FIVE ESTUARIES OFFSHORE WIND FARM

10.64 RESPONSE TO RULE 17 LETTER - 27 FEBRUARY 2025

Application Reference: EN010115
Document Number: 10.64
Revision: A

Fig 17 - Indicative North Falls & Five Estuaries coordinated site plan

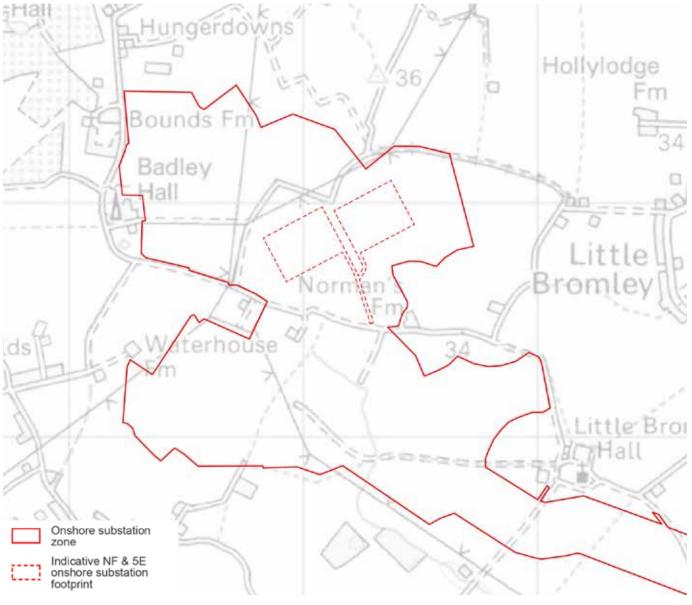
- (b) Identify the information that was presented to the Design Council when it undertook its first review of the proposals for the Five Estuaries and North Falls Offshore Wind Farms in December 2023. In responding to this request for information, the applicant should submit copies of any equivalent versions of Drawings 1 to 4 now included in the Outline Landscape and Ecological Management Plan [REP6-026].

- 4.2.4 At the first review stage, the Applicant and North Falls provided a briefing pack of information this included feedback received from consultations, details on the site context, site constraints and information on the existing visual amenity. It set out the proposed approach by the two projects to design and the proposed red line boundary (as detailed in the PEIR), identifying the indicative co-located compound locations for the two onshore substations.
- 4.2.5 Equivalent versions of Drawings 1 to 4 now included in the OLEMP, or any detailed landscaping concepts, were not available to share at this point, with the DC feedback supporting their development. Appendix 1 includes the limited site layout information provided to the design council to inform the initial discussions.
